## IDAP REPORT

38 Rochester Street Strathfield
<b>Property:</b>	Lot: 1 DP: 950953 DA2020/217
<b>Proposal:</b>	To undertake a two lot Torren's Title subdivision involving the retention of the existing dwelling house on one of the proposed lots.
<b>Applicant:</b>	N Chib
<b>Owner:</b>	R Chib
<b>Date of lodgement:</b>	11 December 2020
<b>Notification period:</b>	13 January to 29 January 2021
<b>Submissions received:</b>	Nil
<b>Assessment officer:</b>	D Strbac
<b>Estimated cost of works:</b>	\$10,000.00
<b>Zoning:</b>	R2 - Low Density Residential - SLEP 2012
<b>Heritage:</b>	No
<b>Flood affected:</b>	Yes
<b>Is a Clause 4.6 Variation Proposed:</b>	No
<b>RECOMMENDATION OF OFFICER:</b>	<b>APPROVAL</b>

*Figure 2: Proposed subdivision plan*

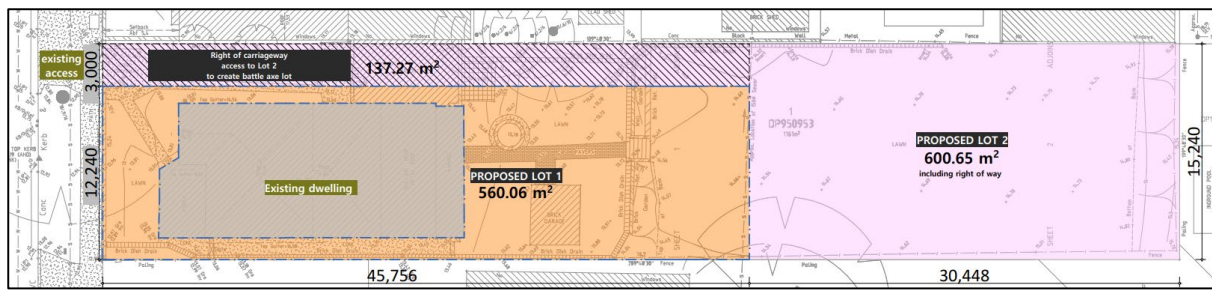
**Comments:** The proposal seeks to subdivide 38 Rochester Street from one (1) lot into two (2) lots in a battle-axe configuration. Both lots comply with the minimum required lot size of 560m<sup>2</sup> under the Strathfield Local Environmental Plan (SLEP) 2012. As shown in the aerial below, the existing allotment at 38 Rochester Street appears to be out of place with surrounding allotments which are significantly smaller in length and area. It is also noted that Rochester Street comprises a number of battle-axe subdivisions which are in the immediate vicinity of the site and are similar to the proposed subdivision. The proposed lots are considered to be consistent with the prevailing subdivision pattern in terms of lot size, shape and dimensions and are therefore supportable.

However, concerns are raised with regards to the close proximity of the proposed stormwater pipe to the northern adjoining site's trees (22 Broughton Road). Accordingly, a condition is recommended in the consent which requires the stormwater pipe to be relocated such that they do not impact on existing trees adjacent to the site. An additional condition is also recommended to ensure that any excavation or ground disturbance within 3m of these trees are undertaken via hand-digging (not machinery).

Concerns are raised for the proposed hardstand area and stormwater services proposed along the northern side boundary, particularly the impact it will have on the trees located at the rear of No. 22 Broughton Road. A condition is therefore recommended which requires the stormwater pipe to be relocated such that they do not impact on existing trees adjacent to the site. An additional condition is also recommended to ensure that any excavation or ground disturbance within 3m of these trees are undertaken via hand-digging (not machinery).

The area of Lot 2 does not comply with the minimum required 560m<sup>2</sup> when the access handle is excluded from the area calculation, as required under the SCDGP 2005. However, as noted in the table below, there are a number of existing allotments along Rochester Street that are also below the prescribed minimum lot size. More specifically, there are eight (8) allotments in the immediate vicinity of the site that comprise a lot area of close to or less than 462.89m<sup>2</sup>. Notwithstanding the departure from the SCDGP 2005, the proposed Lot 2 is still considered to be consistent with the prevailing subdivision pattern in terms of size, shape and dimensions and is therefore supportable.

The proposed lot width (12.24m) does not comply with the minimum lot width requirement. However, this is a pre-existing variation in Rochester Street as the approved subdivisions immediately surrounding the site comprise similar frontages (see table below). The proposed allotment widths are not inconsistent with existing allotments in Rochester Street, and therefore the departure is considered supportable in this instance.

Whilst the proposed vehicular access will have a nil setback from the northern side boundary, there is opportunity to provide a 0.5m landscaping strip on the southern side of the vehicular access. This has been included as a condition in the consent.

Tree Retention	Any stormwater infrastructure servicing Lot 2 shall be relocated so as to not impact on existing trees adjacent to the site. Any excavation or ground disturbance within 3m of these trees is to be undertaken via hand-digging (not machinery). Plans demonstrating compliance with this control shall be submitted to and approved by Council prior to the issue of a Construction Certificate.
Demolition of attached garage	The garage attached to the existing dwelling (located within the access handle) is to be demolished.
Allocation of car parking	A plan is to be submitted showing the allocation of one (1) car parking space behind the building line of Lot 1. Any works required to provide access to this parking must be completed prior to the application for a subdivision certificate.
